# RECAPP Facility Evaluation Report

## Calgary School District #19

### **Annie Foote Elementary School**

**Evaluation Company:** Williams Engineering Canada Inc.  
**Evaluation Date:** September 19 2012  
**Evaluator Name:** WEC - Jennifer Lavier Jankovic

Landing at northwest entry.

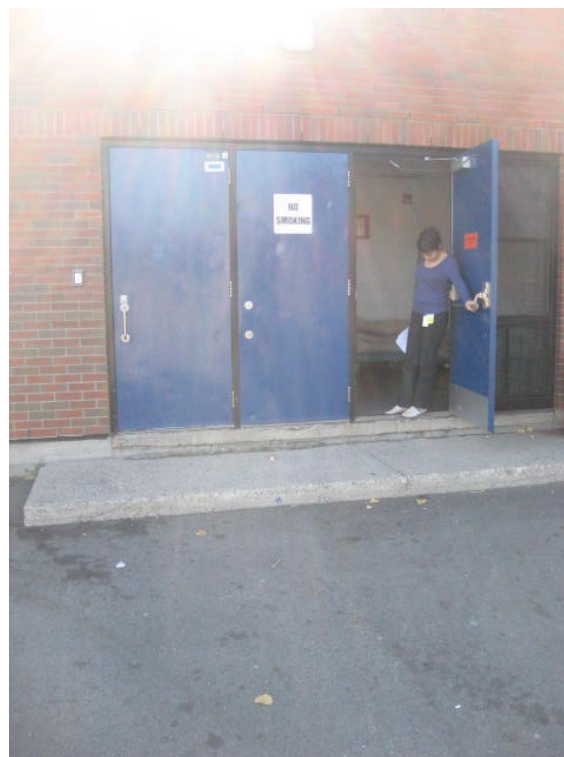
#### Event: Raise landing at north-west exit (1)

Northwest doors have step at entry. By Code 3.4.6.10, step may not exceed 150 mm. Grade has evidently settled since installation.

Raise landing and asphalt.
